UNITED STATES PATENT AND TRADEMARK OFFICE

APPLICATION NO.	FILING DATE	FIRST NAMED INVENTOR	ATTORNEY DOCKET NO.	CONFIRMATION NO.
09/975,630	10/12/2001	Taylor R. Efland	TI-31678	8387

Office Action Summary	Application No. 09/975,630	Applicant(s) EFLAND, TAYLOR R.	
	Examiner Leonardo Andújar	Art Unit 2826

FIG. 1

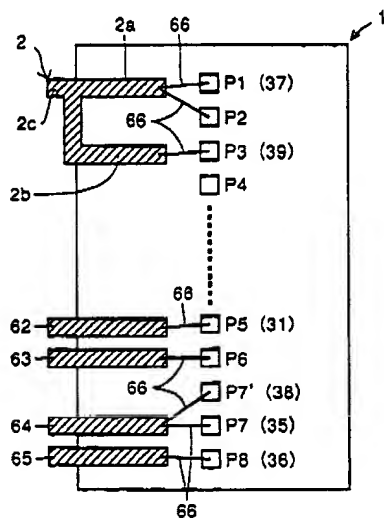
5. Regarding claim 1, Yamasaki (figs. 1-5) discloses a chip 71 having a first and second major opposing surfaces, a circuit having active components such as MOS transistor 70, and a protective overcoat 6 over the first chip surface. Yamasaki, also, shows a network of substantially coplanar power distribution lines 25 laterally disposed on the first surface of the chip over the overcoat and located directly over active

components of the circuit. The lines are conductively connected to the selected active components below the line in a direction normal to the first surface through vias 10 in the overcoat. Moreover, conductors 2b are connected to segments 2c of the lead frame (see fig. 1). As shown in figure 1, conductive members 66 directly connect the power distribution lines to connection regions external to the chip.

FIG. 2B

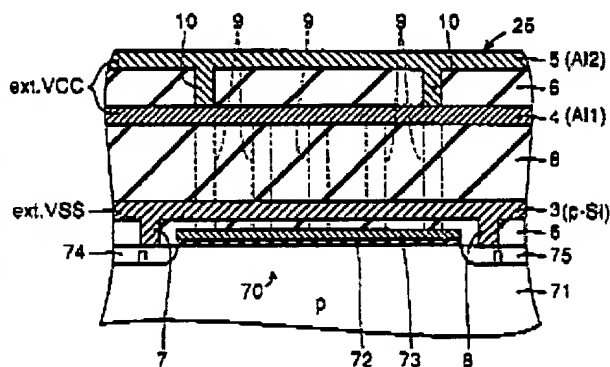
26. Applicant argues that that amended claims 1 and 2 are not taught by the prior art. Nonetheless, Yamasaki shows all the claimed limitations such as a network of substantially coplanar power distribution lines 25 disposed on the first surface of the chip over the overcoat 6 (see fig. 2B). Also, Yamasaki shows vias (e.g., 10) connecting the lines and the active components, and electrically conductive members such as directly connecting the power distribution lines to connection regions external the chip (e.g., 2a). Applicant argues that structure disclosed by Yamasaki is a single transistor structure. Nevertheless, Yamasaki teaches more than one transistor as clearly shown in figure 2b. Note that a sectional view means that the represented unit is repeated. This type of representation is used to avoid redundancy. Moreover, the top view evidenced that more than one transistor are used since several pairs of source/drain electrodes are depicted in figure 2A.
